**HYUNDAI**NEW THINKING.
NEW POSSIBILITIES.**Technical Service Bulletin**

GROUP	NUMBER
CAMPAIGN	11-01-022
DATE	MODEL
JUNE, 2011	SONATA HYBRID (YF HEV)

SUBJECT NVLD INSPECTION/REPLACEMENT AND ECM UPDATE
(SERVICE CAMPAIGN TF9)

Description: For 2011 Sonata Hybrid (YF HEV) vehicles, this bulletin provides a procedure to inspect the NVLD (Natural Vacuum Leakage Detection - Pressure Sensor Assembly) and replace it, if necessary, with a revised part. In addition, it provides a procedure to update the ECM.

**SW 102 = REVISED
SW 103 = REPLACE**

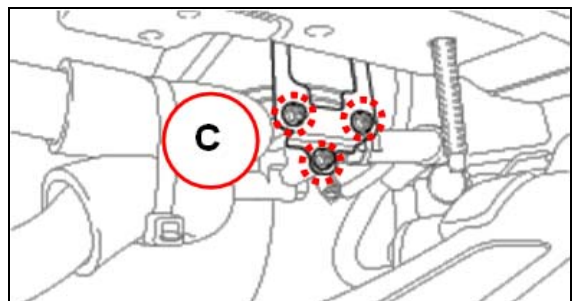
6. Visually inspect the top cover of the NVLD assembly to read the “SW” version.

- NVLD assemblies with “**SW 102**” are revised parts. **DO NOT REPLACE.**
Possible Part Numbers:
 - **31480-4R000**
 - **31480-4R100**
- NVLD assemblies with “**SW 103**” are old version parts and **must be replaced.**
Possible Part Numbers:
 - **31480-4R000**

**Example of a revised NVLD assembly:
P/N 31480-4R100 with “SW 102”**

**Example of a revised NVLD assembly:
P/N 31480-4R000 with “SW 102”**

Regardless of the part number, NVLD assemblies with “SW 102” stampings are revised parts that should be reinstalled. **DO NOT REPLACE.**
